Technical Service Bulletin

SUBJECT:		No: TSB-25-42-002	
DOOR AJAR WARNING LIGHT COMES ON WHEN REAR DOOR IS CLOSED		DATE: April 2025	
		MODEL: See below	
CIRCULATE TO:	<input type="checkbox"/> GENERAL MANAGER	<input checked="" type="checkbox"/> PARTS MANAGER	<input checked="" type="checkbox"/> TECHNICIAN
<input checked="" type="checkbox"/> SERVICE ADVISOR	<input checked="" type="checkbox"/> SERVICE MANAGER	<input checked="" type="checkbox"/> WARRANTY PROCESSOR	<input type="checkbox"/> SALES MANAGER

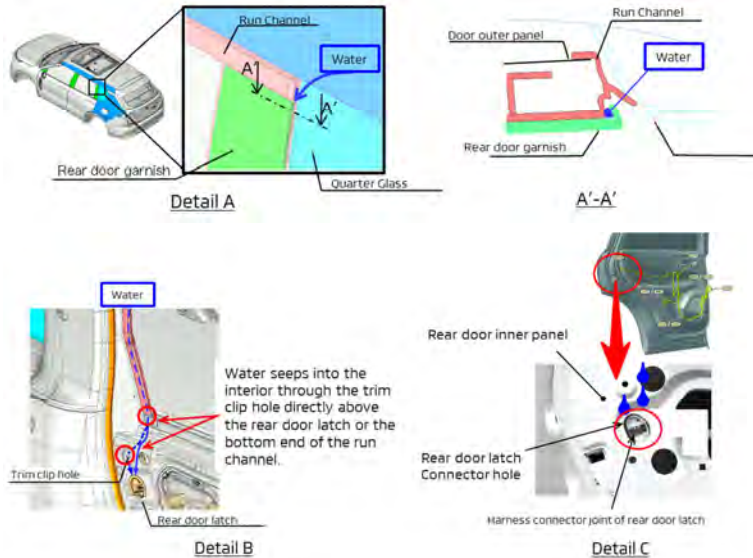
When it rains or when washing the car, water may seep in behind the top of the rear door garnish (see Detail A). If water runs down the back of the rear door run channel and enters the trim clip hole directly above the rear door latch or at the bottom end of the run channel on the interior side of the rear door panel (see Detail B) and makes contact with the connector joint between the rear door latch and the door harness (see Detail C), the door ajar detection signal circuit will connect and the door warning light will come on. To prevent water from seeping in to the rear door latch connector, a waterproof sponge has been added to the rear door trim clip and sealer has been added to the rear door latch channel.

To prevent water from getting into the rear door latch connector, ① and ② have been added:

- ① A waterproof sponge has been added to the rear door trim clip.
- ② EPT sealer has been added to the rear door latch channel.

There are six procedure remedies for vehicles where ① has been applied, and for vehicles where both ① and ② have not been applied, on both the left and right sides. Please refer to the Service Manual as needed.

Replace RH side rear door latch and rear door harness + Replace the run channel and door trim clip with a waterproof sponge.
